CITY OF ALBUQUERQUE

Re: Nusenda Credit Union
6401 Uptown Blvd NE
Traffic Circulation Layout
Architect's Stamp 10-28-25 (H18-D012)

Based upon the information provided in your submittal received 10-29-25, the above referenced plan cannot be approved for Building Permit until the following comments are addressed:

1 site plan
 A001 1"=20'

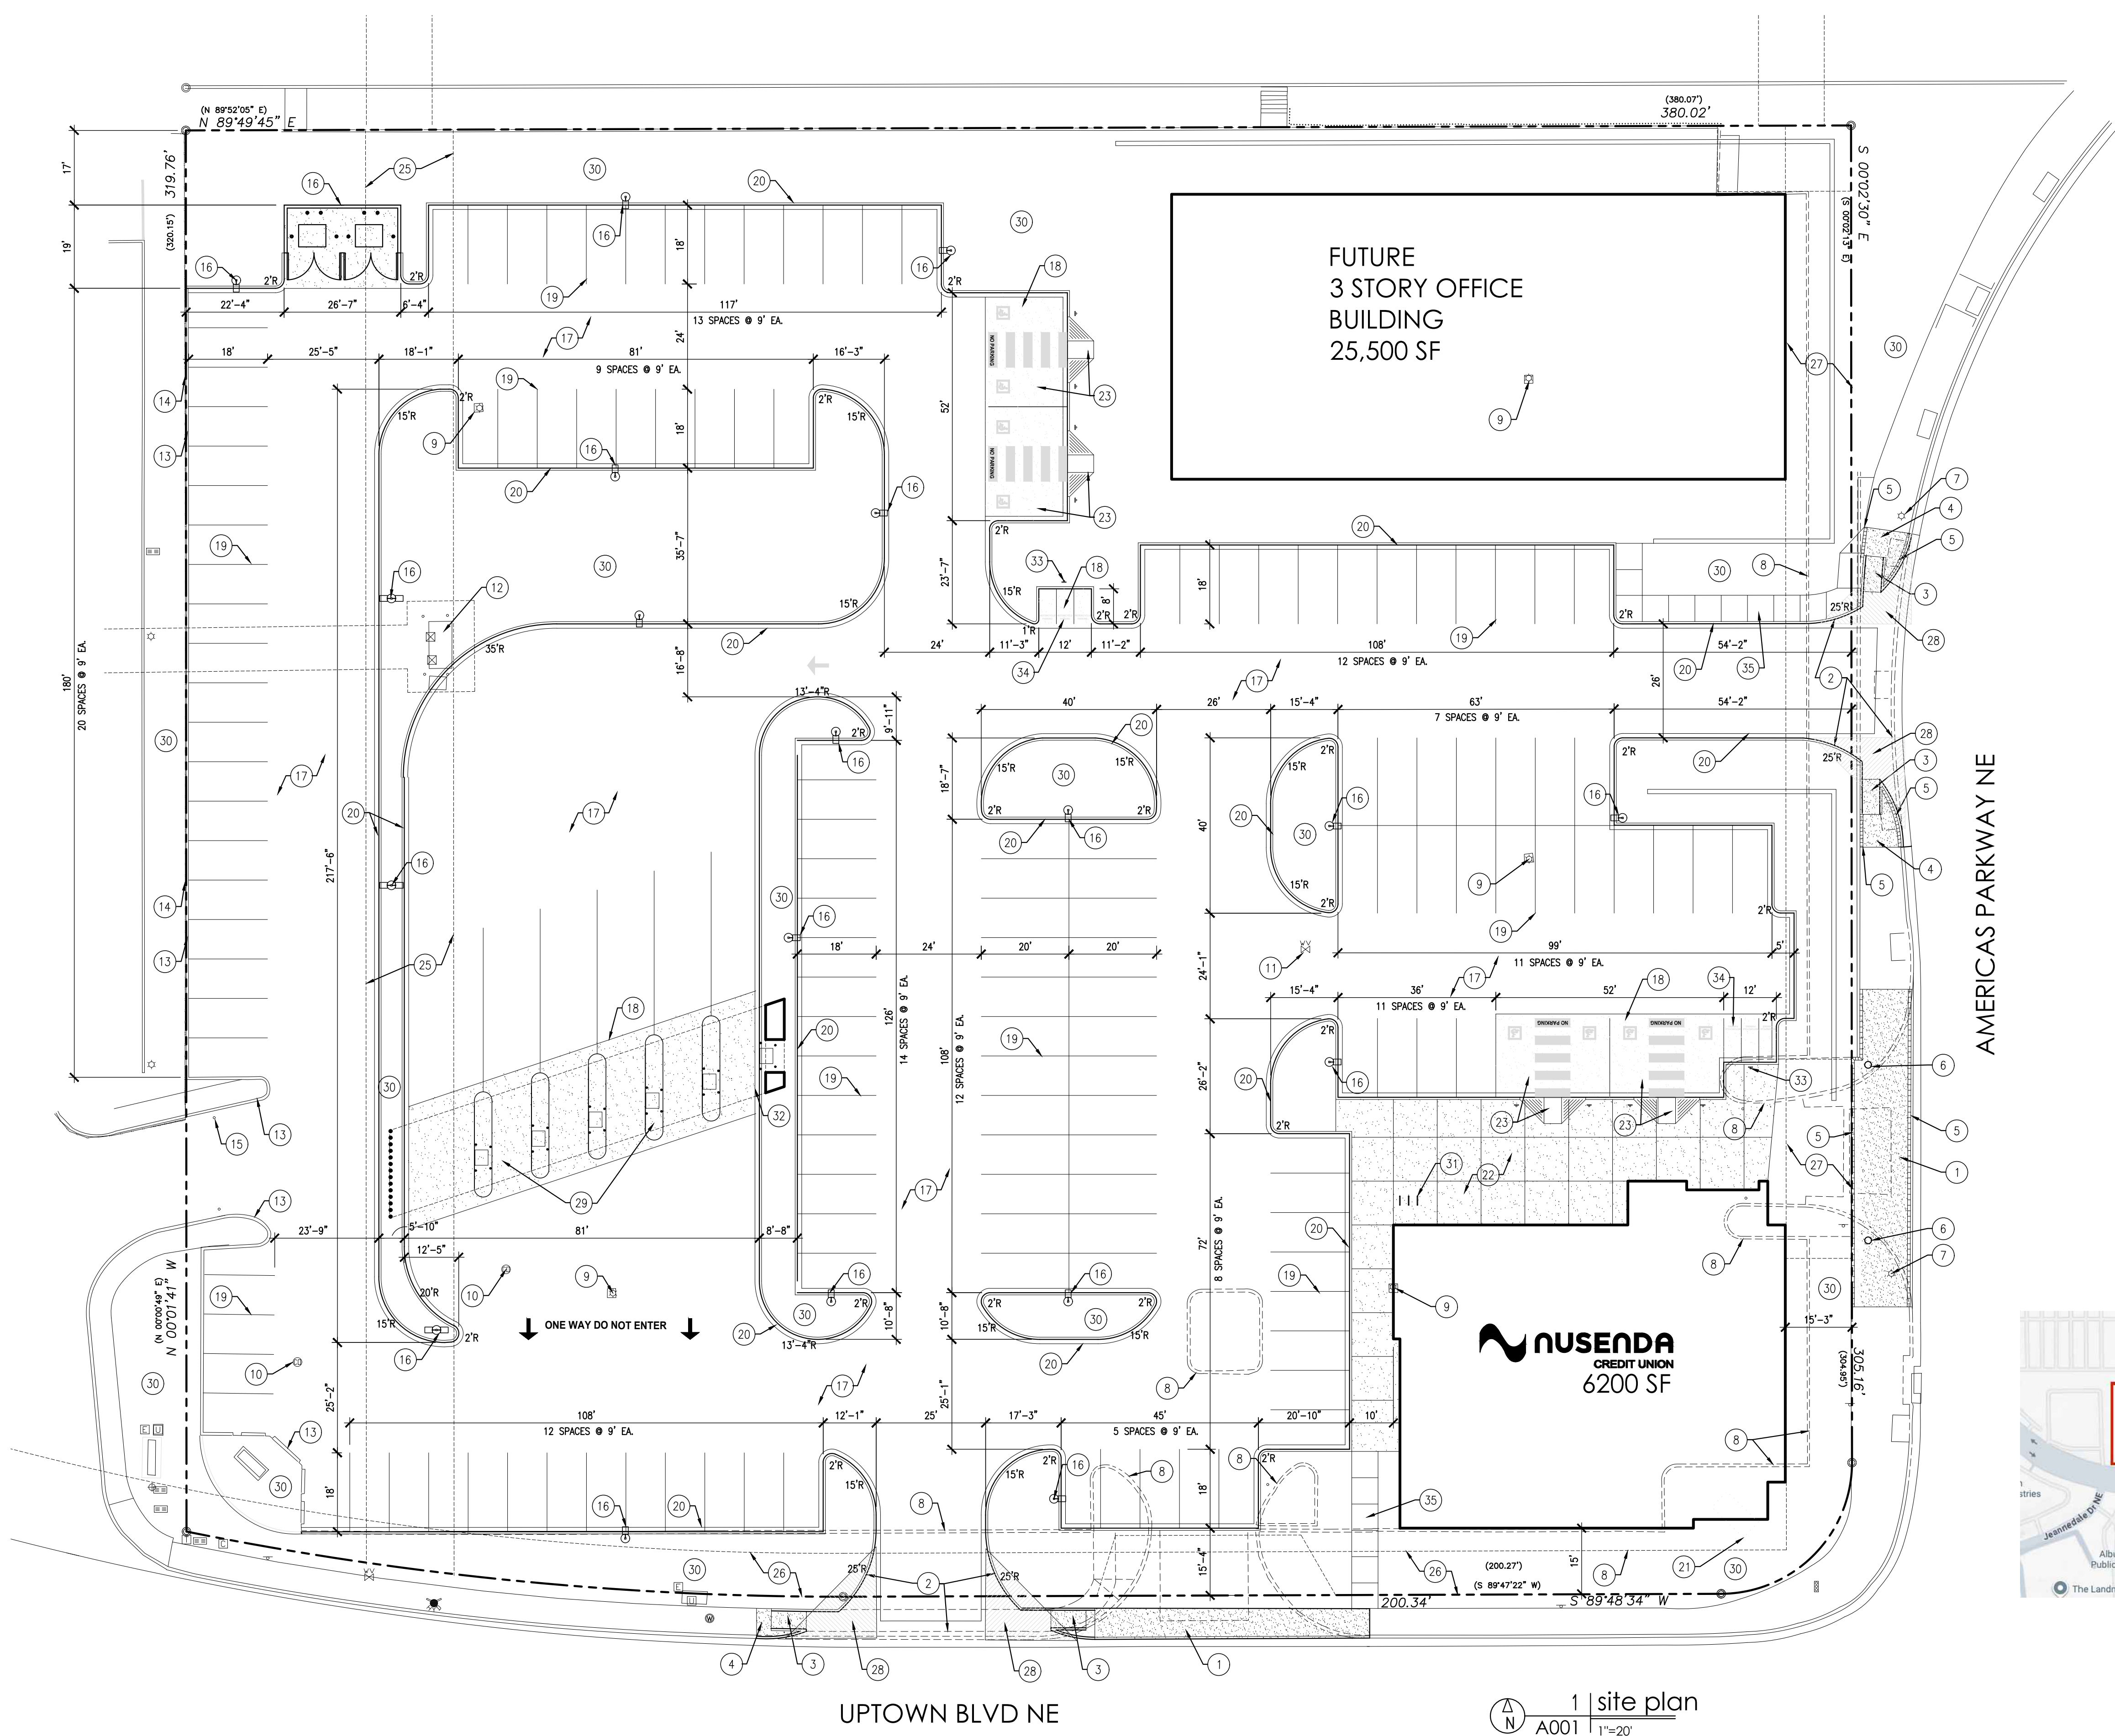
1. List the number of parking spaces required by the IDO as well as the proposed number of parking spaces including bicycle and motorcycle parking.
2. Identify the right of way width, medians, curb cuts, and street widths on Americas Pkwy and Uptown Blvd.

3. Provide shared access agreement with the adjacent west side property, or submit an approved plat demonstrates shared access agreement.
4. Each drive-thru lane shall be 12ft in width.

5. All one-way drives shall have "One Way" and "Do Not Enter" signage and pavement markings. Please show detail and location of posted signs and striping.

6. ADA corner ramp at the intersection of Americas Pway and Uptown Blvd must be updated to current standards and have truncated domes installed.
7. It appears there is a fire hydrant on the sidewalk along Uptown Blvd. Per city requirements and standard dwg 2431, a minimum 4 ft wide clear pathway must be provided around the obstruction.

- The clear sight triangle must be located at the back of the sidewalk for all site accesses.

- Provide a copy of Solid Waste and Fire Marshal approval.
- Add a note stating "All broken or cracked sidewalk must be replaced with sidewalk and curb & gutter." A build note must be provided referring to the appropriate City Standard drawing.
- Please provide a letter of response for all comments given.
